IFB No. IFB No. 22-24 HVAC Upgrades at Lathrop, Spring Creek and Bloom Schools

RE: ADDENDUM NO. 4

**Subject :** Addendum No. 004  
To the Bid Documents For:  
RPS IFB number 22-24  
Spring Creek, Lathrop, & Bloom Elementary  
HVAC Upgrades  
Rockford, Illinois

Sheet Title:  
FIRST FLOOR PLAN -  
MECHANICAL NEW  
WORK - AREA 1

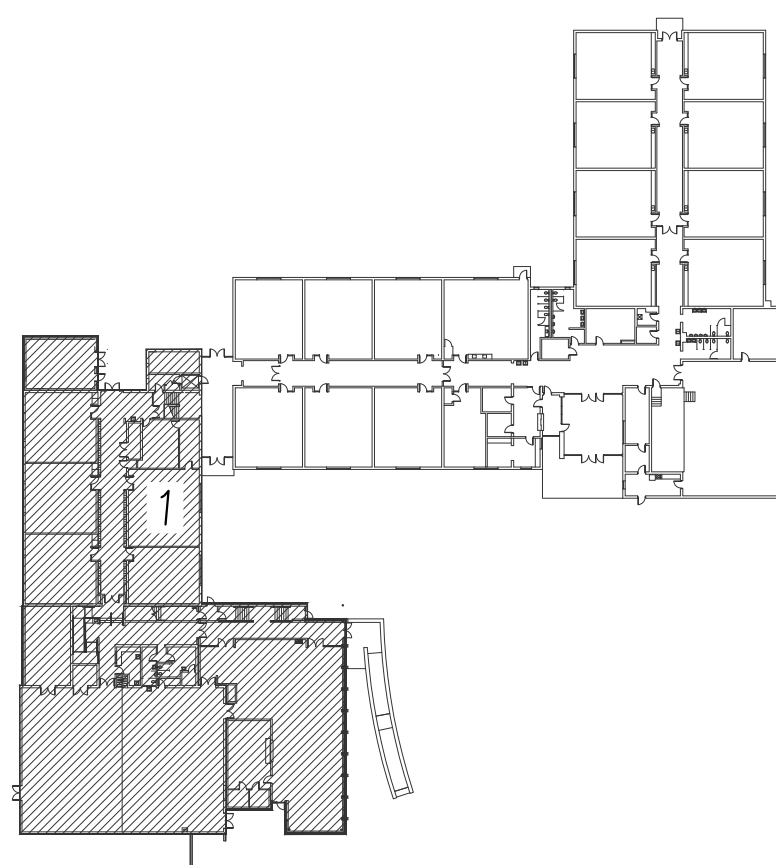
3. Drawing M111 – First Floor Plan – Mechanical New Work – Area 1
  - a. Notes added for cabinet unit heater installation. See attached sheet M111.
4. Drawing M112 – First Floor Plan – Mechanical New Work – Area 2

Proj. No.: 2249  
Date: 02/18/2022  
Drawn: AEC  
Approved: RCR  
Sheet No.: M112

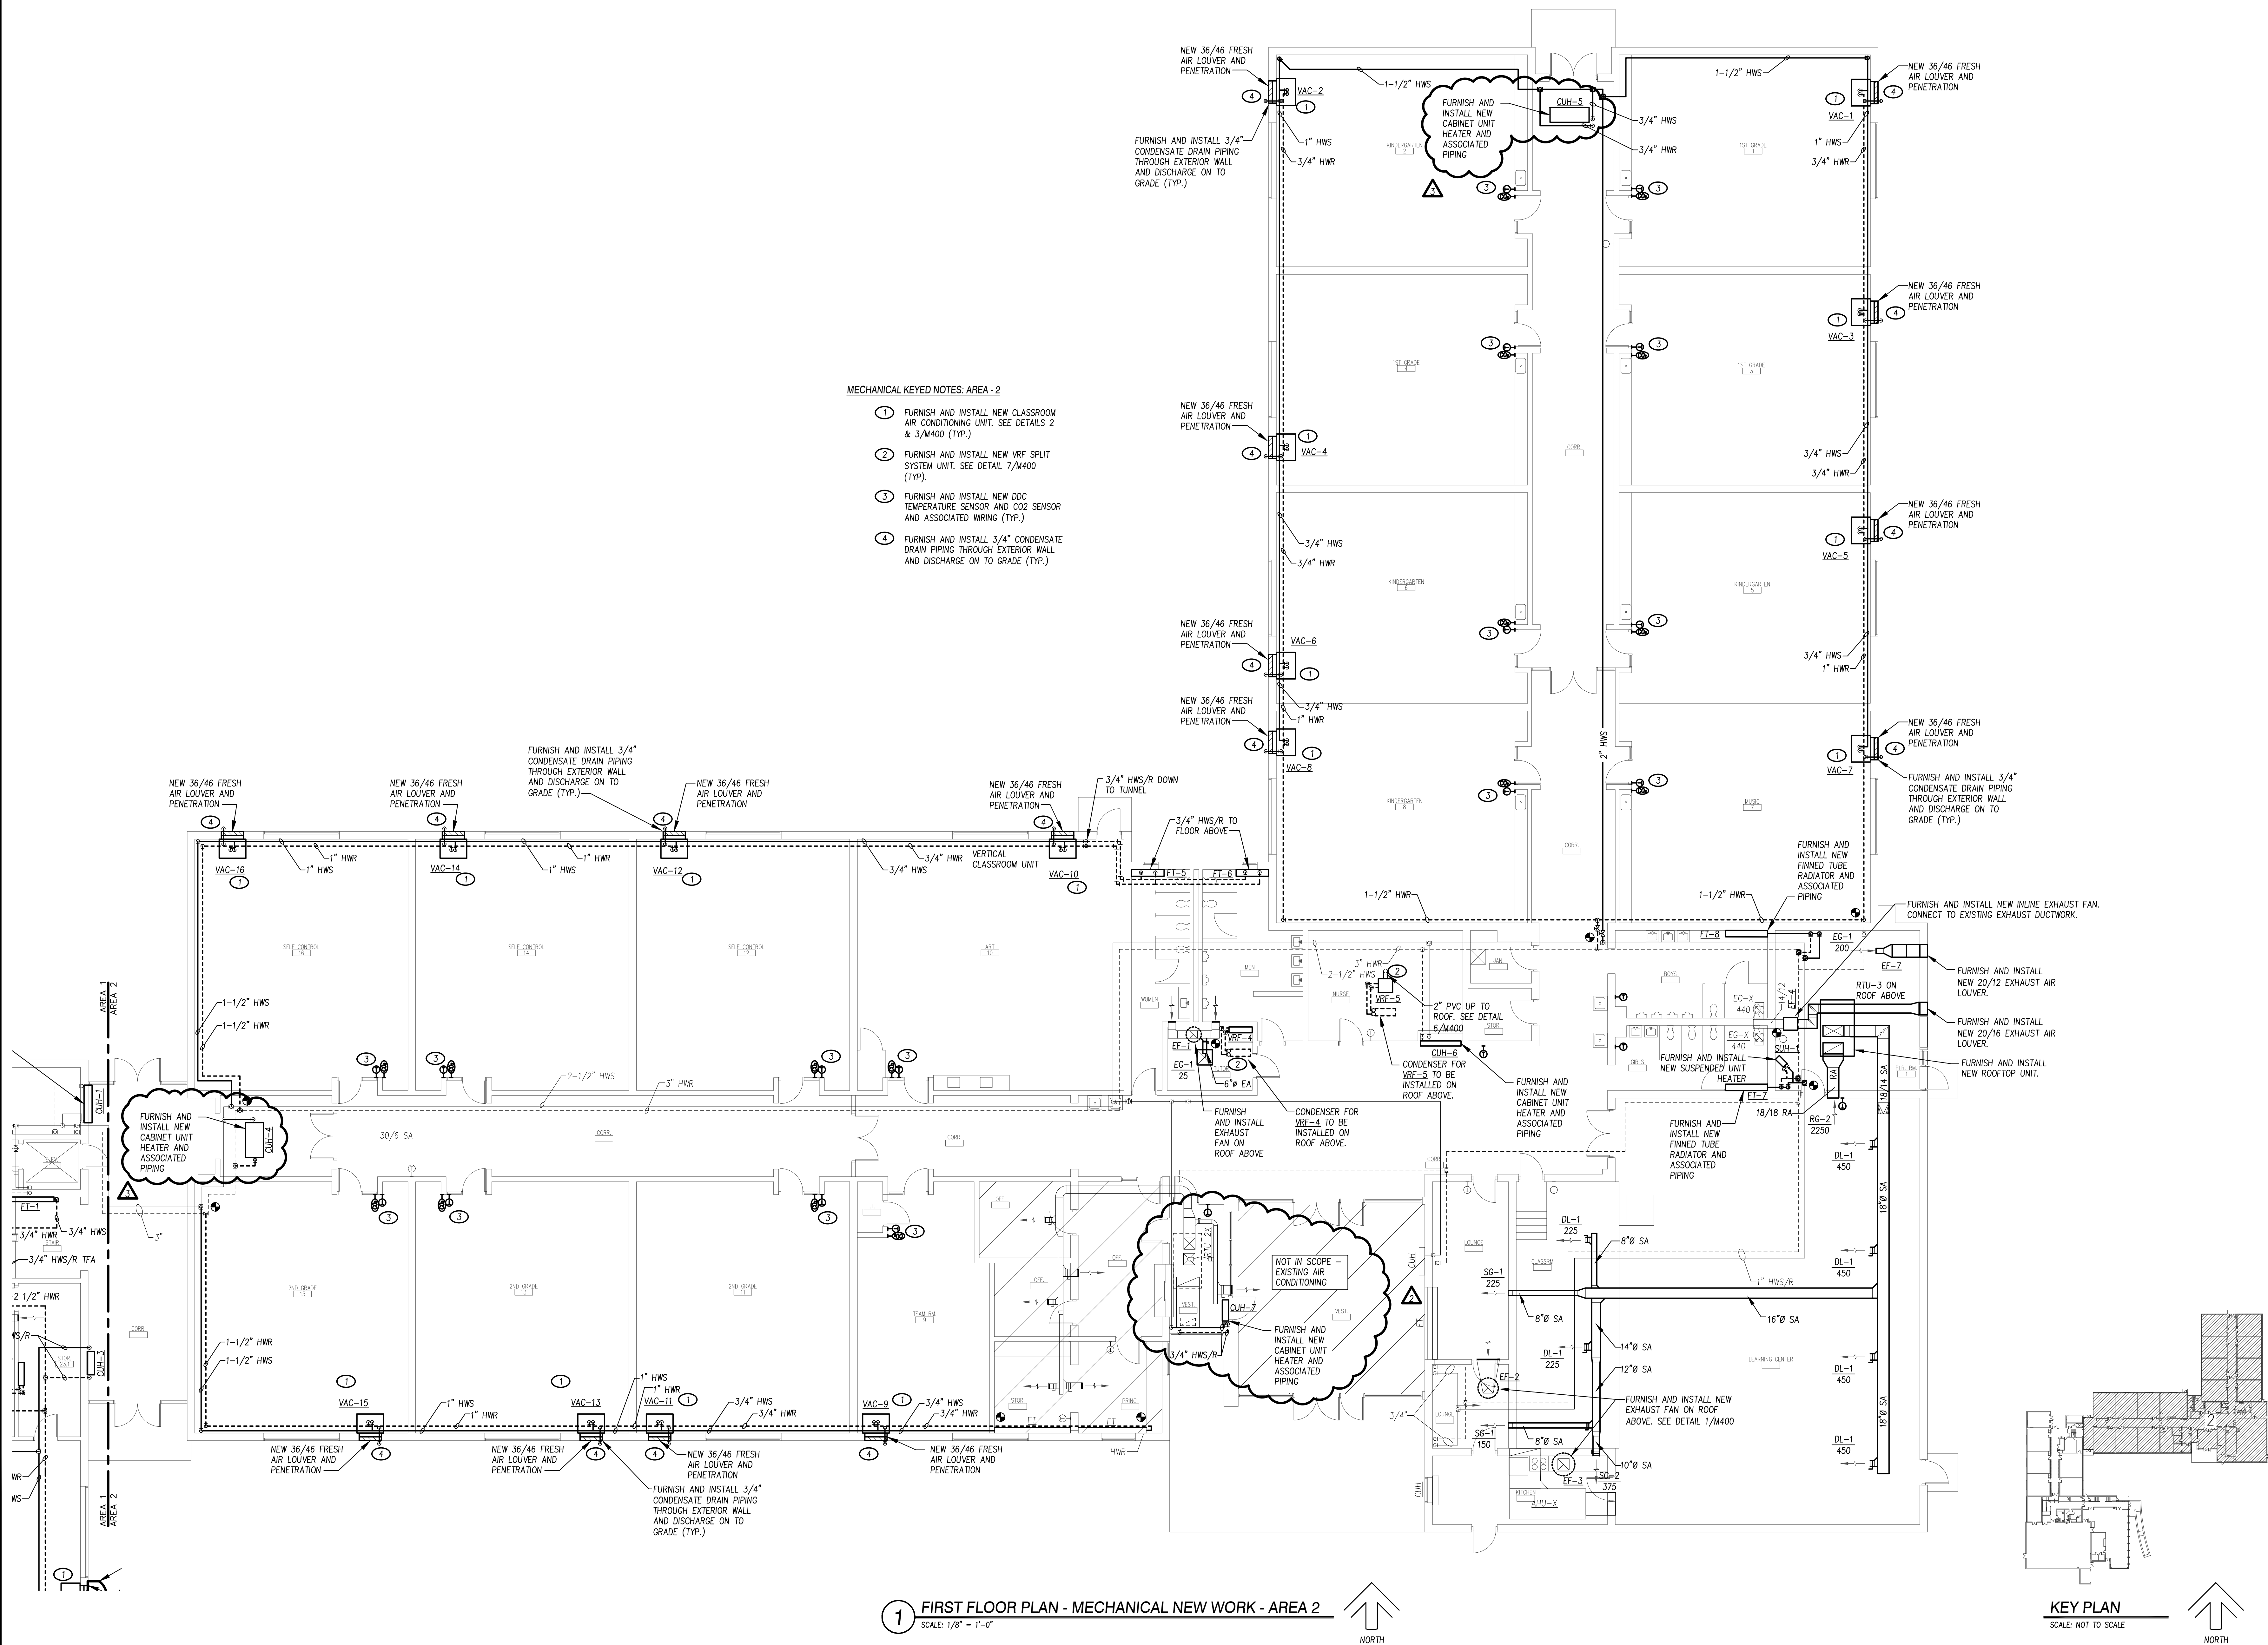
- a. Notes added for cabinet unit heater installation. See attached sheet M112.
5. Drawing M500 – Mechanical Notes and Schedules
  - a. Packaged Classroom Air Conditioning Unit Schedule

Sheet Title:  
FIRST FLOOR PLAN -  
MECHANICAL  
AREA 1

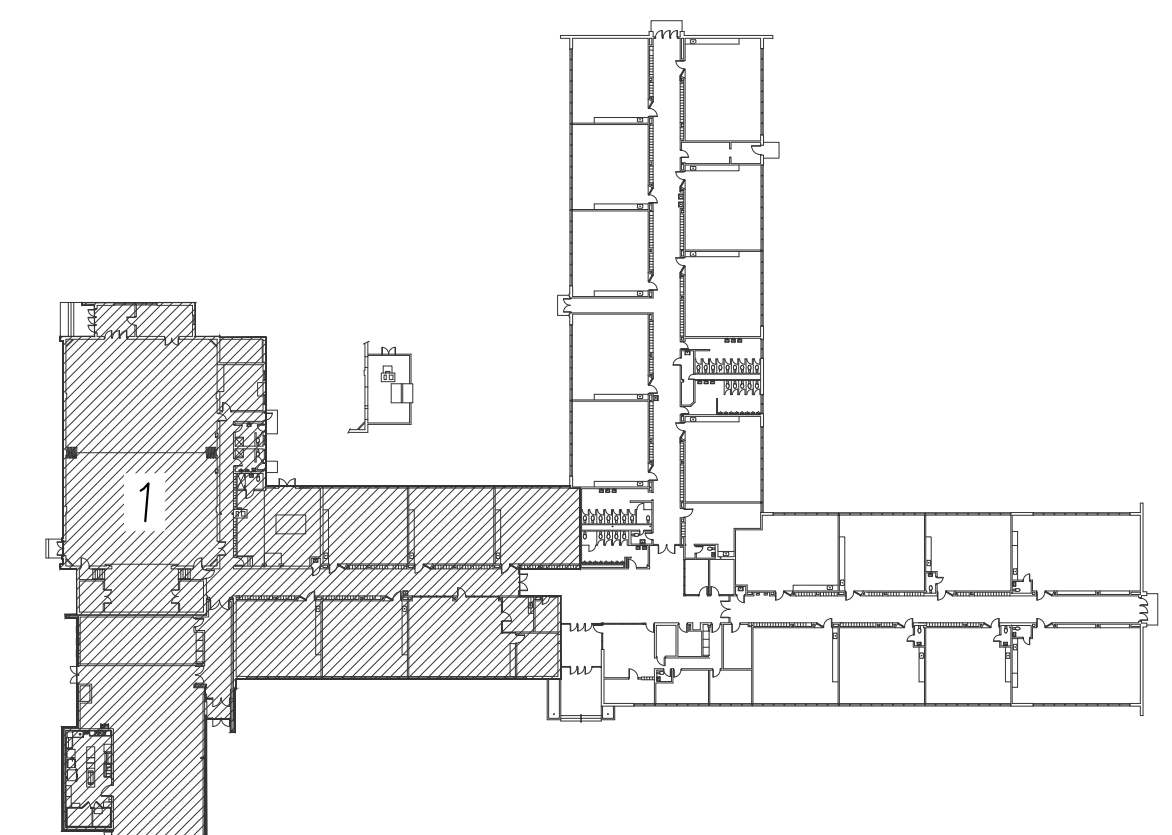
- a. Add entire sheet.
8. Drawing M111 – First Floor Plan – Mechanical – Area 1
  - a. Furnish and install new heat pump units VRF-1 and VRF-2 in Lounge 6 and P.E. Storage 8 as shown on attached sheet M111.
